**Re: Paramount Resources Ltd.'s ("Paramount") Cameron Hills Oil and Gas Development Project Approved under National Energy Board ("NEB") Order EPO-01-2002 - C-50 Grid 60<sup>0</sup> 10' N, 117<sup>0</sup> 30' W ("C-50") Pipeline Failure**

**CAMERON HILLS GAS GATHERING**

**REPAIR DETAIL**

DRAWING NUMBER: D-CH-G-50-P-02.03

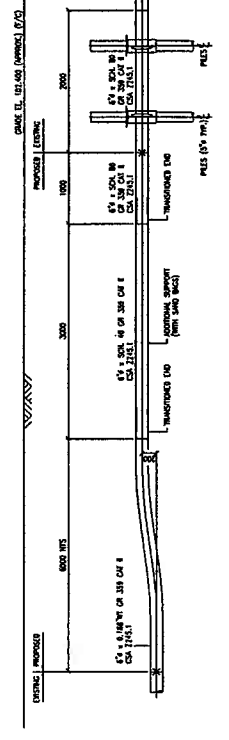
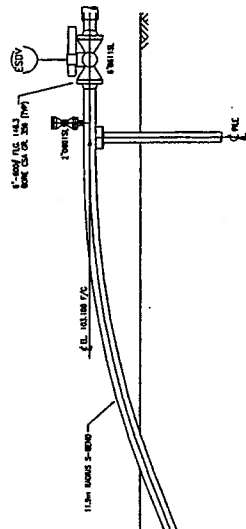
1. The transition from 11 mm to 4.8 mm wall pipe will be done in two steps with 7.2 mm wall pipe as an intermediate step. The purpose of this is to increase the flexibility and reduce the stress concentration of the pipe joining onto the anchor. A drawing is attached for reference.

2. Approximately eighteen feet of line pipe will be pre-bent to accommodate the 8" offset that has occurred due to settling. This will reduce the stresses on the pipe at the anchor.

3. The two transition pieces and pre-bent pipe spool will be welded together using the same welding procedure that was used during the original construction.

4. All the welds on the completed spool will be inspected by radiography on the full circumference of the welds.
5. A 1 hour hydrostatic test of the entire spool piece will be performed at fabrication shop.

6. The pipe spool will be transported to site and the spool will be welded in place using the same welding procedure that was used during the original construction.

7. The tie-in welds will be inspected by radiographic and ultrasonic methods.
8. Sand bags will be used to support the pipe at 3 m intervals where it does not rest on the trench floor.
